St Leonards South DA Review

Area 13,14 and 15

13 February 2024

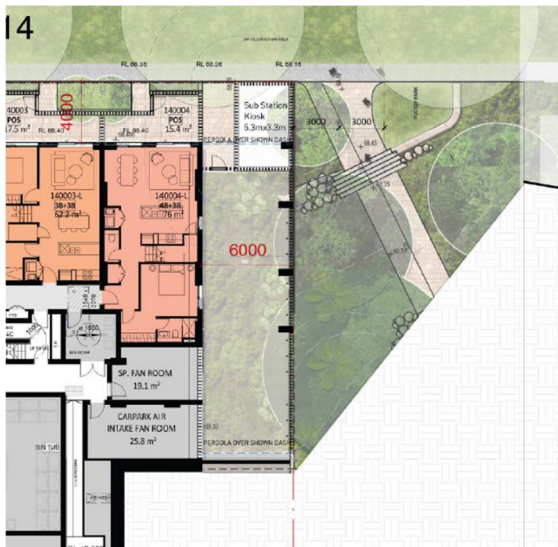
The lowering of the green spine between Areas 14 and 15 from the recommended levels of the Landscape Master Plan has resulted in a greater grade change having to be addressed within the green spine. This has resulted in the bunching up of terraces around the area 12 boundary and a disjointed communal open space overall.

As noted in council comments, an at-grade connection between the green spine and pedestrian link should be secondary to a functional communal open space within the green spine.

Ensure that the play elements provided within the green spine provide for a range of opportunities for different ages and in particular play for the very young. Play elements should be consistent and integrated with the overall character of the landscape.

Raise the height of the green spine between Areas 14 and 15 to RL 74-75, and to RL 76-77 adjacent to Area 13 (i.e. more in line with the Landscape Master Plan) to reduce ramping and terracing within the green spine.

The change to the design to adjust the Green Spine levels to more closely reflect those suggested in the Landscape Master Plan (i.e., southern portion of Green Spine at RL 74.5 and northern portion at RL 76.5) is strongly supported.
